# SR 125/SR 32 FOCUS AREA ADVISORY COMMITTEE MEETING NOTES

## MEETING #3 NOTES

August 20, 2018

**Figure X-1B**

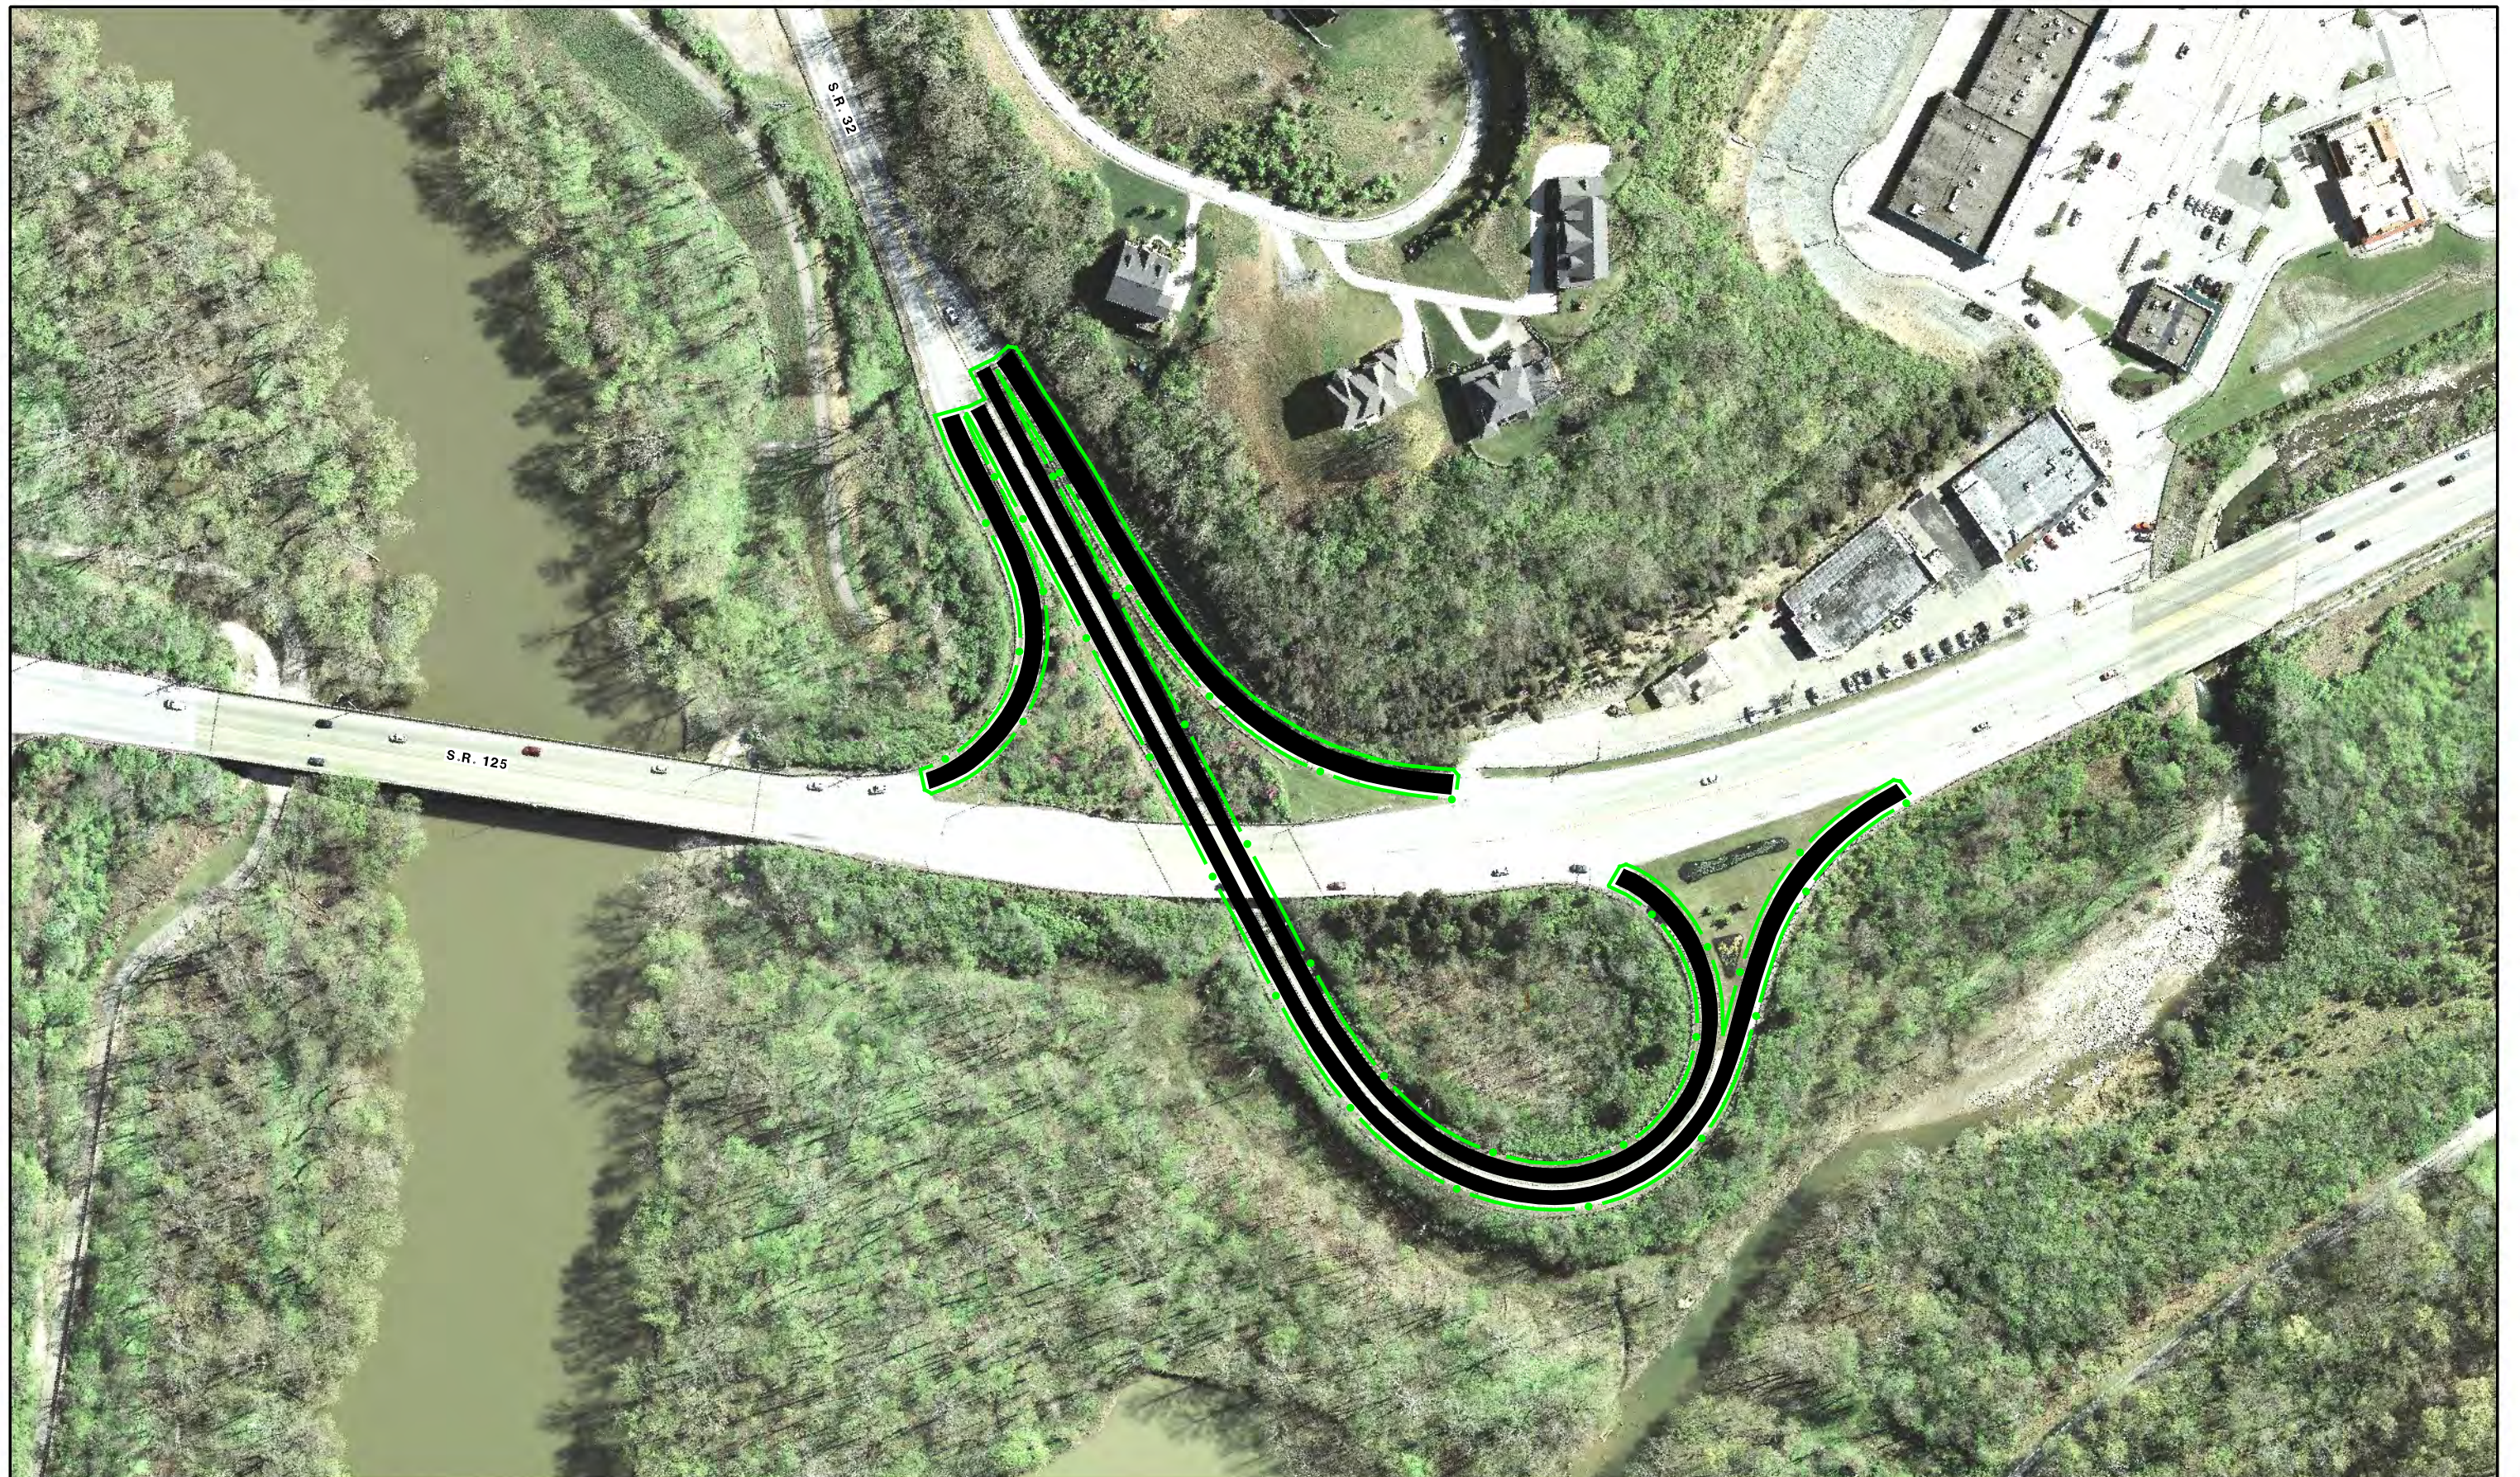
- It is anticipated that installing friction pavement will be an effective, low-cost option for this area.
- There is a resurfacing plan in place for SR 32 in this area; adding friction pavement on the ramps can be integrated into this plan. Therefore, there is no need to create a stand-alone project for this concept.

- Advance, possibly with planned ODOT 2024 resurfacing project (PID 105215).

Figure X-1E

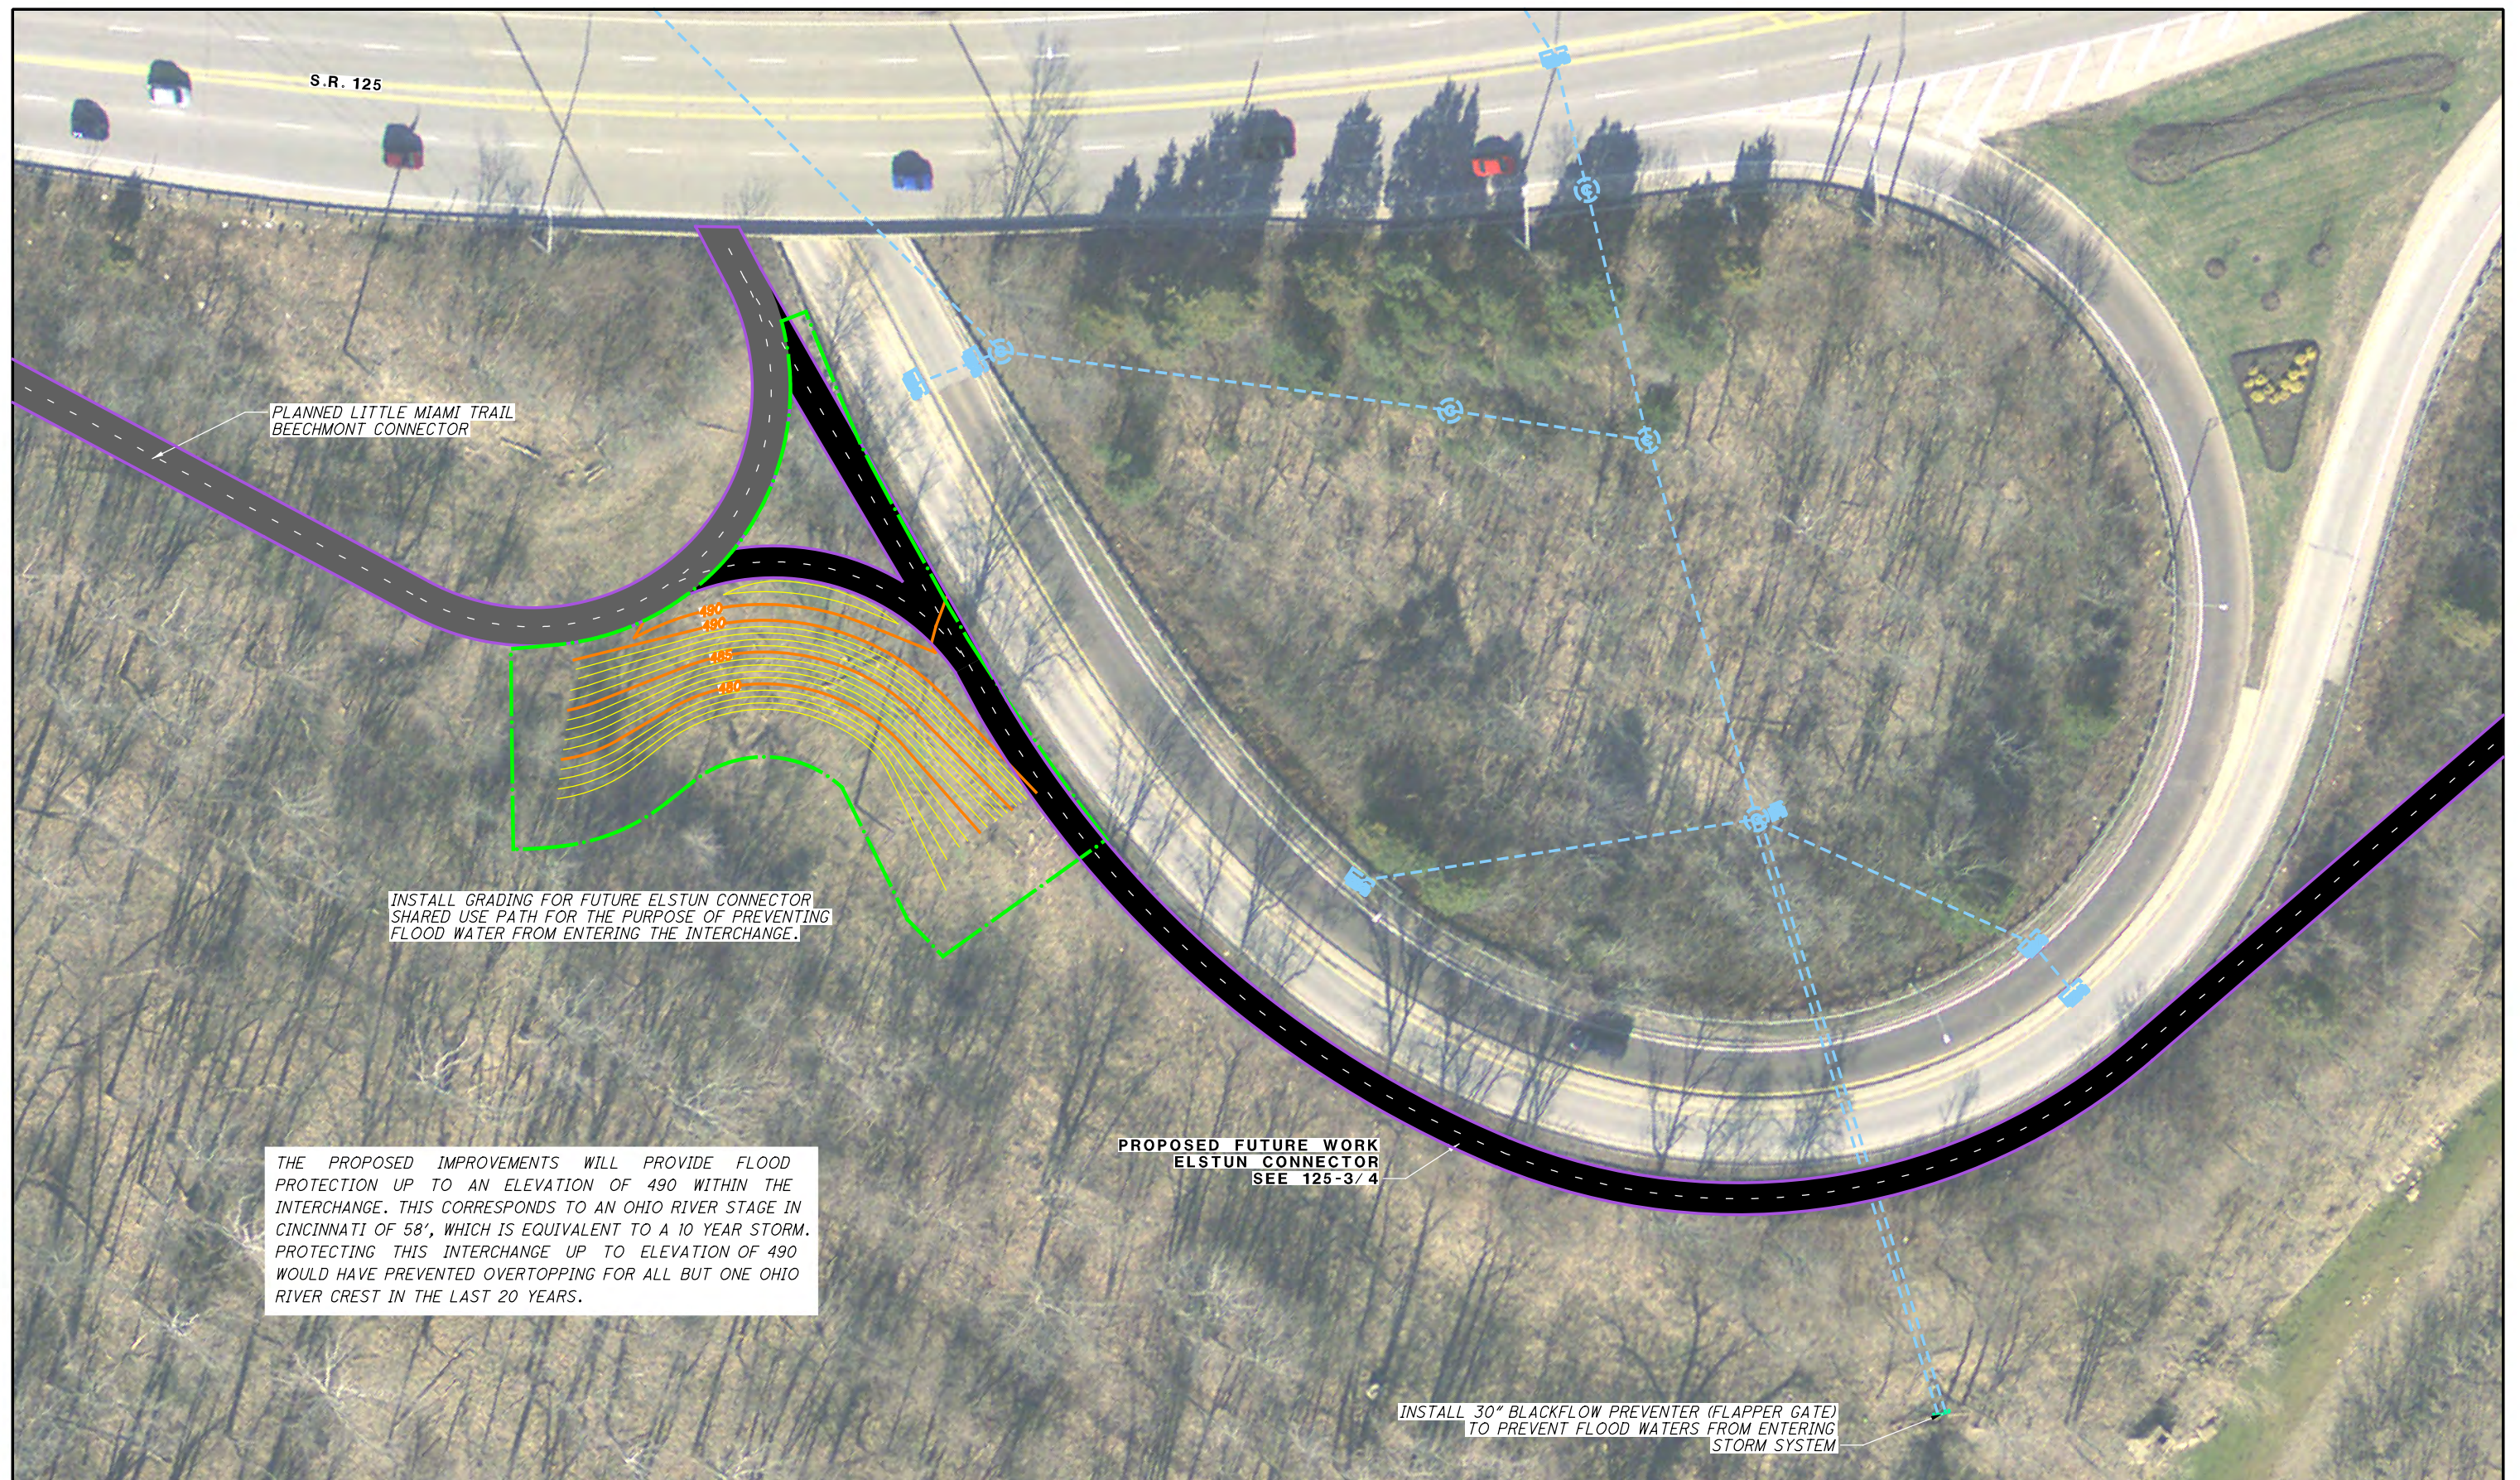
- The purpose of this project is to address flooding on the ramp that connects SR 125 and SR 32 under the levee; ODOT/Stantec are coordinating this effort with Great Parks and the City of Cincinnati.
- Flooding occurs in this area in one of two ways:
  - Water backflows from overloaded storm drains.
  - Water levels in the Ohio River rise above 58 feet - the equivalent of a 10-year storm- and backs up into the Little Miami River.
- Proposal is two-fold:
  - Install a 30” backflow preventer (flapper gate) in the storm water system to prevent flood waters from entering the system and overflowing in vicinity of the ramp.

- Pre-grade the land for the future Elstun Connector shared use path. Grading would create a large berm that would prevent floodwater from spilling into the interchange ramps.
  - Grading would provide flood protection up to an elevation of 490 feet.
  - This measure would have prevented all but one flooding event in the past 20 years.
- Though these measures won’t address all flooding issues, they are expected to address at least 90% of them for approximately \$35K to \$53K.
- Recommendation is to grade rather than install pumps as previously suggested.

- Advance revised proposal (backflow preventers and grading), possibly with planned 2021 bikeways connector project (PID 107295).
